SUBJECT: PALO VERDE NUCLEAR GENERATING STATION, UNITS 1, 2, AND 3 -  
ISSUANCE OF AMENDMENTS RE: TECHNICAL SPECIFICATIONS  
CHANGES TO MINIMUM REFUELING WATER TANK VOLUME AND  
SETPOINTS (TAC NOS. ME2842, ME2843, AND ME2844)

SAFETY EVALUATION BY THE OFFICE OF NUCLEAR REACTOR REGULATION  
RELATED TO AMENDMENT NO. 182 TO FACILITY OPERATING LICENSE NO. NPF-41,  
AMENDMENT NO. 182 TO FACILITY OPERATING LICENSE NO. NPF-51, AND  
AMENDMENT NO. 182 TO FACILITY OPERATING LICENSE NO. NPF-74  
ARIZONA PUBLIC SERVICE COMPANY, ET AL.  
PALO VERDE NUCLEAR GENERATING STATION, UNITS 1, 2, AND 3  
DOCKET NOS. STN 50-528, STN 50-529, AND STN 50-530

FIGURE 3.5.5-1  
Minimum Required RWT Volume

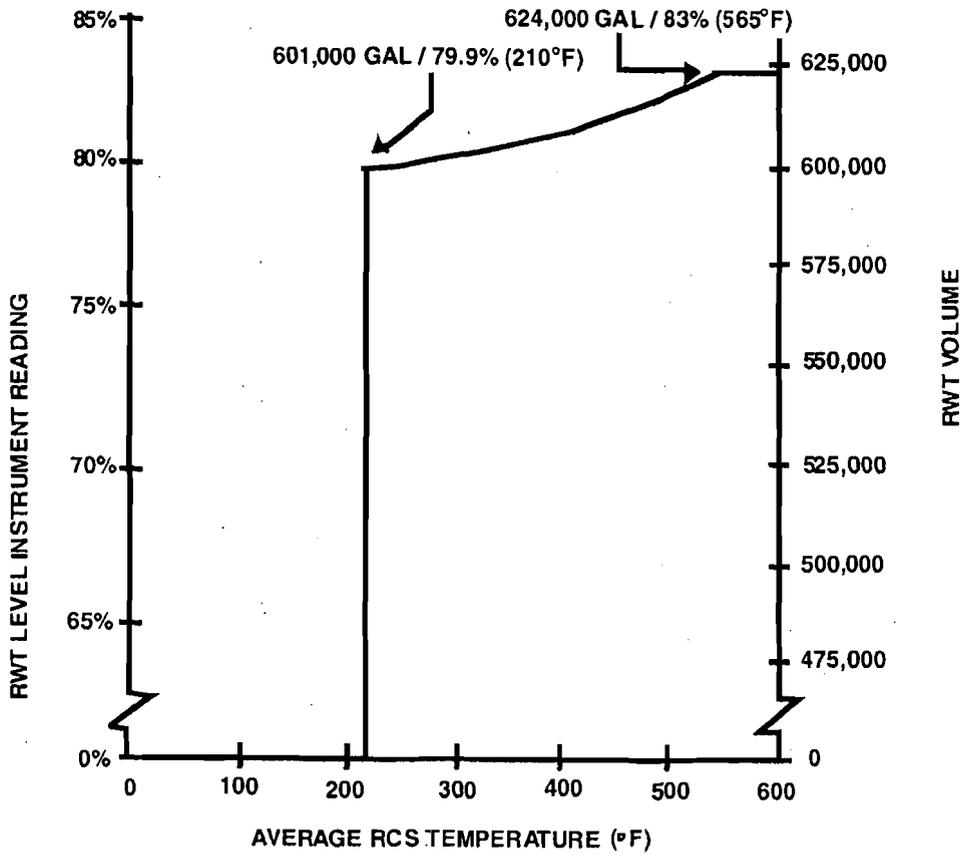
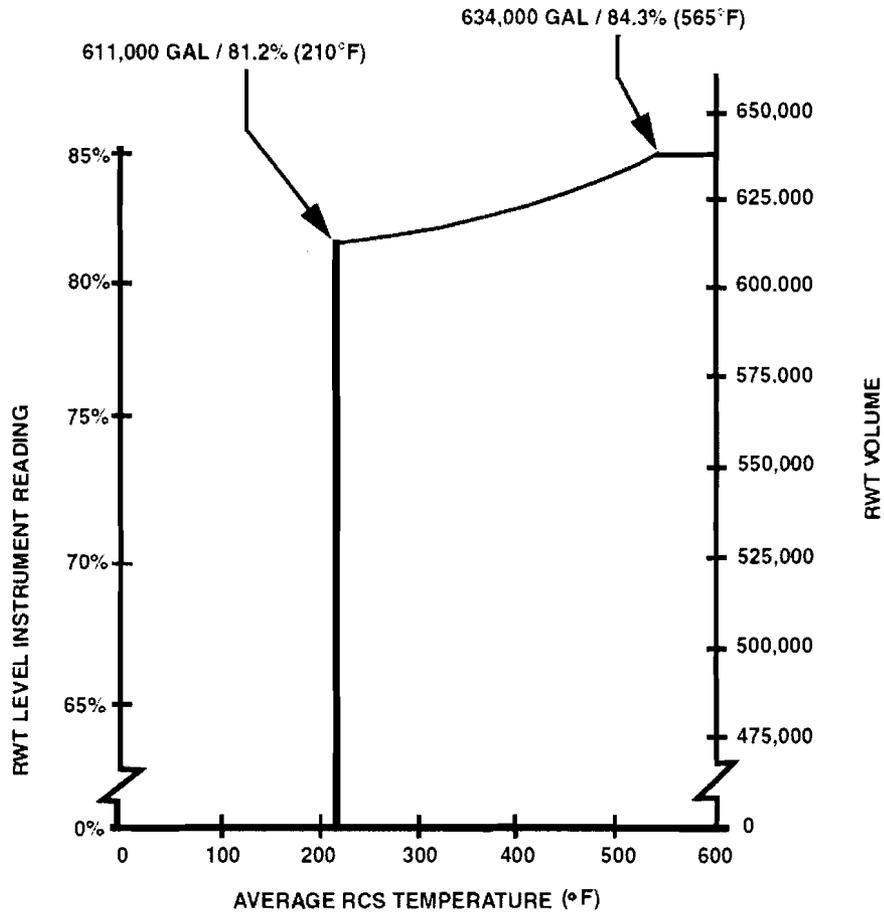
3. Increase TS 3.5.5, Figure 3.5.5-1, minimum required RWT volume values at 210 °F from "601,000 gallons" to "611,000 gallons" and at 565 °F from "624,000 gallons" to "634,000 gallons," to accommodate the proposed (higher) RAS setpoint AVs. The minimum RWT volume between 210 °F and 565 °F shown in TS Figure 3.5.5-1 would be increased proportionally from 611,000 gallons to 634,000 gallons. These changes would ensure that sufficient borated water would be delivered from the RWT during ECCS injection mode before switchover occurs at the proposed higher RAS setpoint.

In order to ensure that there will be adequate borated water volume available for the design functions of the RWT, the proposed changes will raise the associated minimum required RWT volumes in TS Figure 3.5.5-1 used to determine operability of the RWT for the range of temperatures from 210 degrees Fahrenheit (°F) through 600 °F. The minimum required volume at 210 °F will change from 601,000 gallons/79.9 percent to 611,000 gallons/81.2 percent; the minimum required volume at 565 °F (through 600 °F) will change from 624,000 gallons/83 percent to 634,000 gallons/84.3 percent; and the corresponding minimum required volumes for temperatures between 210 °F and 565 °F will be raised proportionally. The proposed TS changes will ensure that the RWT water volume is maintained above the vortex breaker during the initial phase of an accident, prior to isolation of the RWT. This is intended to prevent air ingestion in ESF pump suction piping from an emptying RWT. It will also ensure that there is adequate water volume available in the containment to meet functional requirements of the ESF pumps and the containment sump strainers for applicable design-basis accidents and break scenarios. In addition, the licensee evaluated the impact of this proposed TS change on post-LOCA sump pH and found that the current calculated maximum post-LOCA sump pH remains bounding for the proposed increase in the TS minimum RWT water level.

The NRC staff has reviewed the proposed TS changes to increase the minimum required RWT borated water volumes in TS Figure 3.5.5-1. These proposed TS changes are intended to prevent air ingestion from the RWT to ESF pump suction following an RAS and will assure that there is adequate water volume available in the containment to meet functional requirements of the ESF pumps and the containment sump strainers for applicable design-basis accidents and break scenarios. The licensee's evaluation demonstrates compliance with the regulatory requirements of 10 CFR 50.36(c)(3), 10 CFR 50.46(b)(5), and GDCs 35 and 38, and is consistent with the guidance in NRC Generic Letter 2008-01. Therefore, the NRC staff concludes that the proposed TS changes are acceptable.
